DART SERVICE INSTRUCTION

TO AMEND INSTALLATION INSTRUCTIONS IIN-D119-646 REV. C
AND INSTRUCTIONS FOR CONTINUED AIRWORTHINESS ICA-D119-646 REV. 2
REF FAA STC: SR02024SE
REF EASA STC: 10040294

The purpose of this Dart Service Instructions is to add D119-646-313/-314 Skidtube Protector Kit to make the D119-646-011/-012/-111/-112/-211/-212 Skidtube Kits compatible with the 109-0812-68-105 Hoist Structural Provision Kit and the 109-0816-18-301 Rappelling Kit. The D119-646-313 Skidtube Protector, LH replaces the 109-B710-05-201 kit and the D119-646-314 Skidtube Protector, RH replaces the 109-B710-05-202 kit.

FIGURE 1: D119-646-314 SKIDTUBE PROTECTOR KIT, RH (SHOWN)
 (D119-646-313 SKIDTUBE PROTECTOR, LH (OPPOSITE))
 (SHOWN INSTALLED ON D119-646-011/-012/-111/-112 SKIDTUBES)

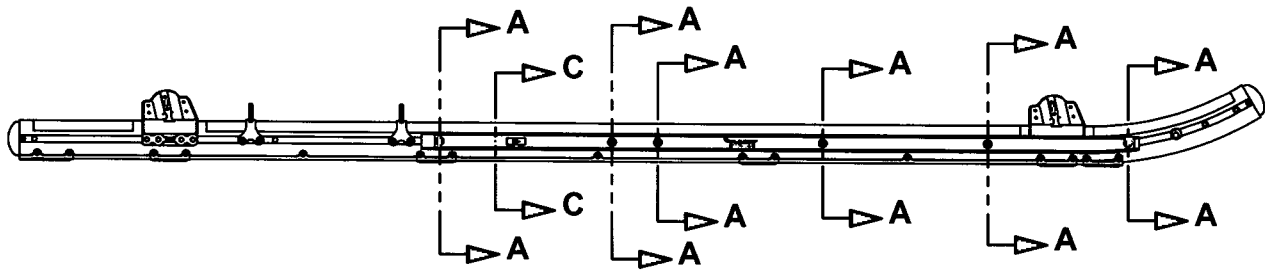
- 2.13 Install D5369-2 Cable Guard on the RH side of the aircraft using 6x AN3-47A bolts, 6x D5374-1 Bushings, 6x D4506-3 Washers, 12x NAS11490D332J washers, 6x MS21042L3 nuts as shown in Figure 1 Section A-A. Torque bolts to 15-25 in-lbs (1.7-2.8 N-m).

- 2.14 Install D5369-1 Cable Guard on the LH side of the aircraft using 6x AN3-47A bolts, 6x D5374-1 Bushings, 6x D4506-3 Washers, 12x NAS11490D332J washers, 6x MS21042L3 nuts as shown in Figure 1 Section A-A. Torque bolts to 15-25 in-lbs (1.7-2.8 N-m).

FIGURE 2: D119-646-314 SKIDTUBE PROTECTOR KIT, RH (SHOWN)
 (D119-646-313 SKIDTUBE PROTECTOR, LH (OPPOSITE))
 (SHOWN INSTALLED ON D119-646-211/-212 SKIDTUBES)

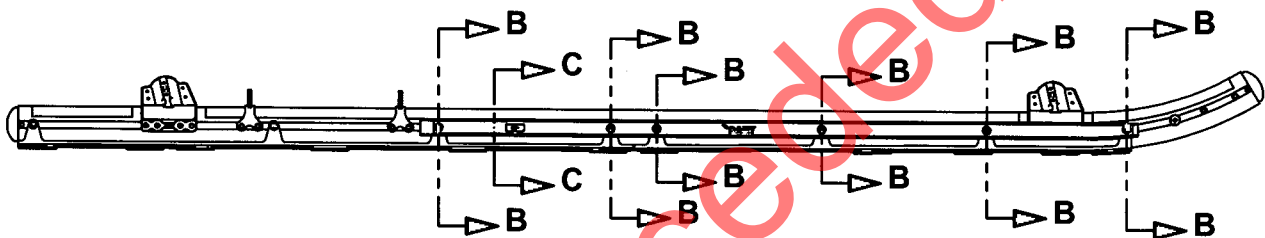
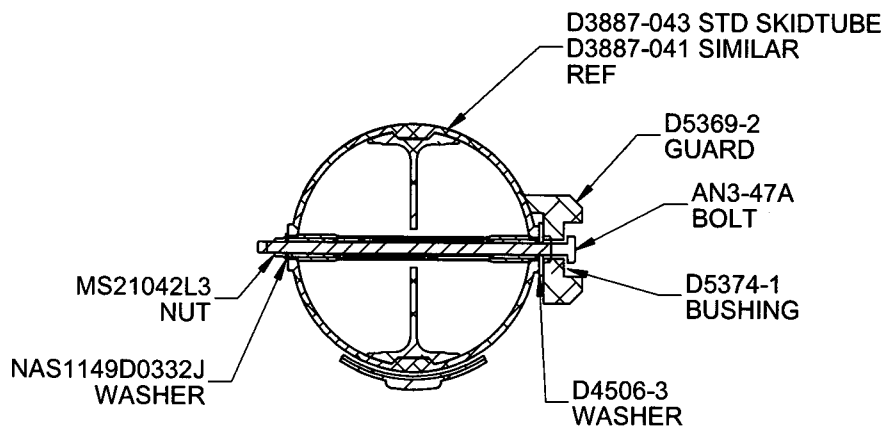
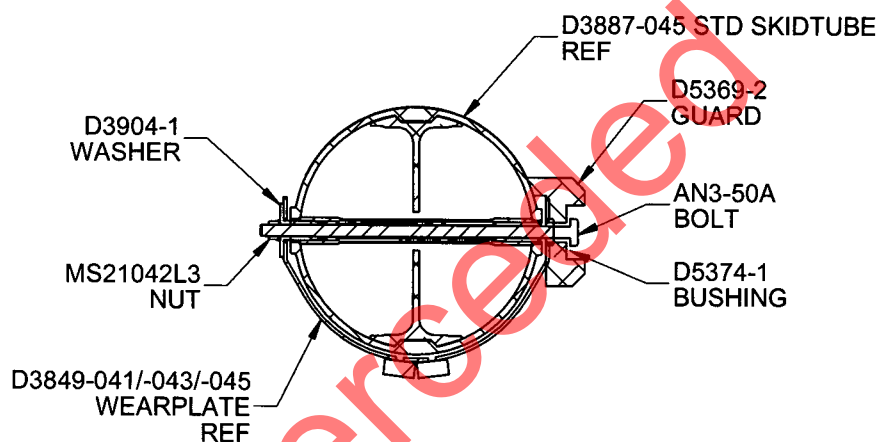
- 3.14 Install D5369-2 Cable Guard on the RH side of the aircraft using 6x AN3-50A bolts, 6x D5374-1 Bushings, 6x D3904-1 Washers, 6x MS21042L3 nuts as shown in Figure 2 Section B-B. Torque bolts to 15-25 in-lbs (1.7-2.8 N-m).

- 3.15 Install D5369-1 Cable Guard on the LH side of the aircraft using 6x AN3-50A bolts, 6x D5374-1 Bushings, 6x D3904-1 Washers, 6x MS21042L3 nuts as shown in Figure 2 Section B-B. Torque bolts to 15-25 in-lbs (1.7-2.8 N-m).

FIGURE 3: USING D5376-1 DRILLING JIG

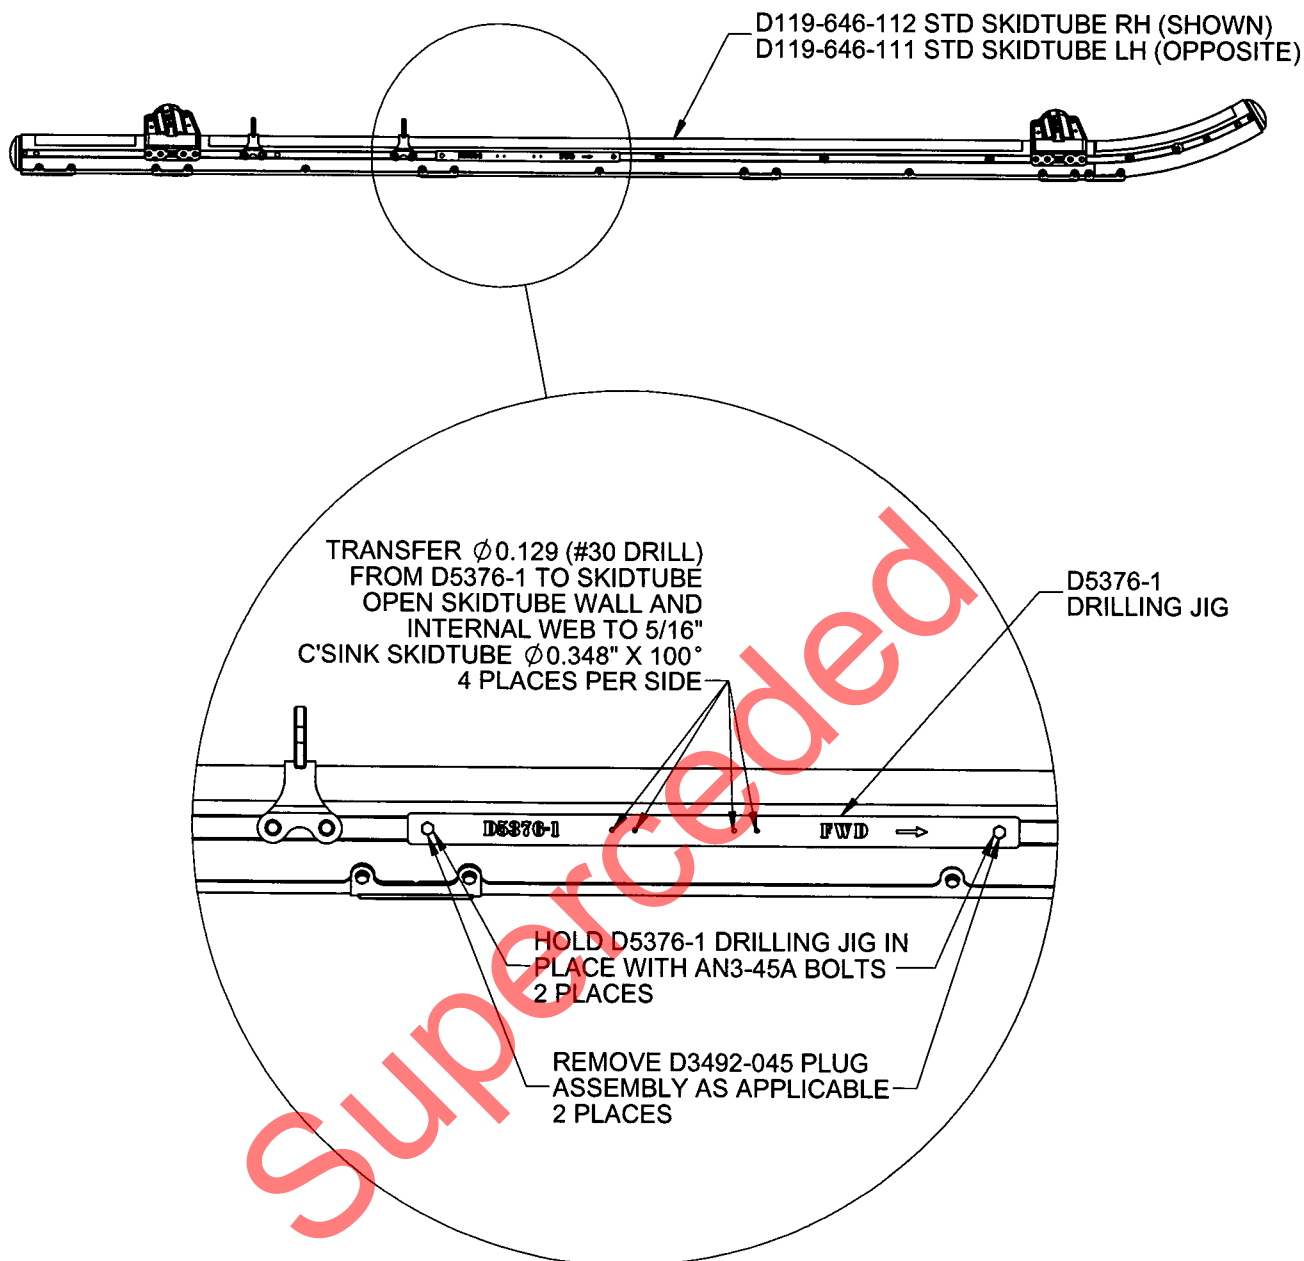
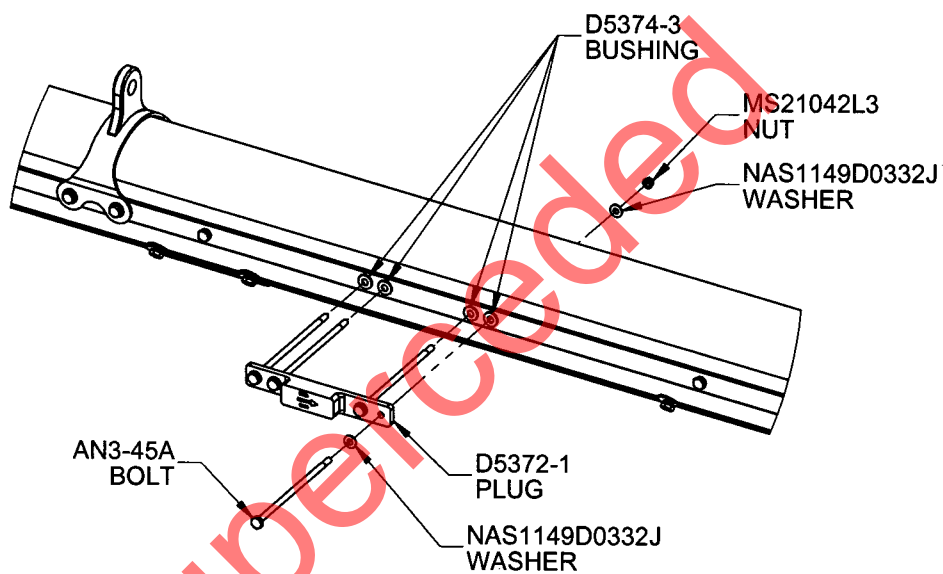
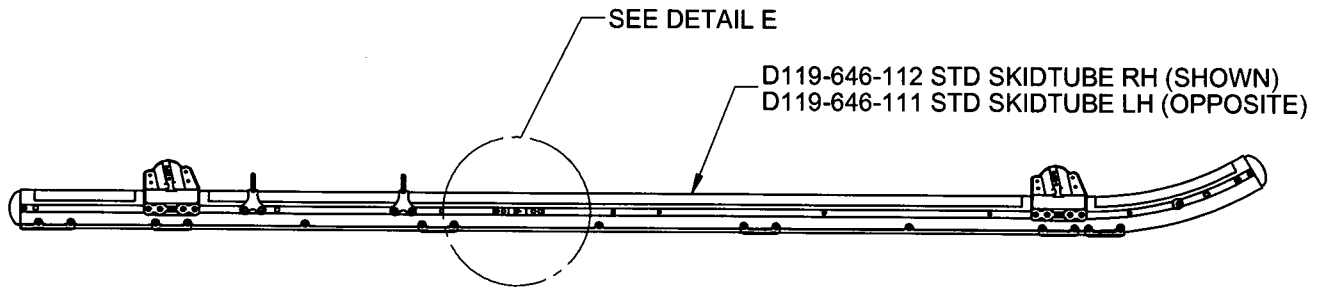
- 2.1 Remove D3492-045 Plug Assemblies from two locations on each side of the skidtube as shown in Figure 3.
- 2.2 Position D5376-1 drilling jig tool with the arrow pointing fwd as shown in Figure 3. Use 2x AN3-45A bolts to hold the jig in place. Transfer drill 4x $\varnothing 0.129$ " (#30 drill) holes from D5376-1 drilling jig to skidtube ridge as shown in Figure 3. **Caution:** Drill perpendicular to the skidtube ridge.

- 2.4 Countersunk 4x 5/16" holes to $\varnothing 0.348$ " (8.84mm) x 100° as shown in Figure 3 and deburr.
- 2.5 Repeat steps 2.2 to 2.4 for the opposite side of the skidtube.

- 3.1 Temporarily remove D3849-043 Training Wearplate from aft end of the skidtube per ICA-D119-646 Section 32.
- 3.2 Position D5376-1 drilling jig tool with the arrow pointing fwd as shown in Figure 3. Use 2x AN3-45A bolts to hold the jig in place. Transfer drill 4x $\varnothing 0.129$ " (#30 drill) holes from D5376-1 drilling jig to skidtube ridge as shown in Figure 3. **Caution:** Drill perpendicular to the skidtube ridge.

- 3.4 Countersunk 4x 5/16" holes to $\varnothing 0.348$ " (8.84mm) x 100° as shown in Figure 3 and deburr.
- 3.5 Repeat steps 3.2 to 3.4 for the opposite side of the skidtube.
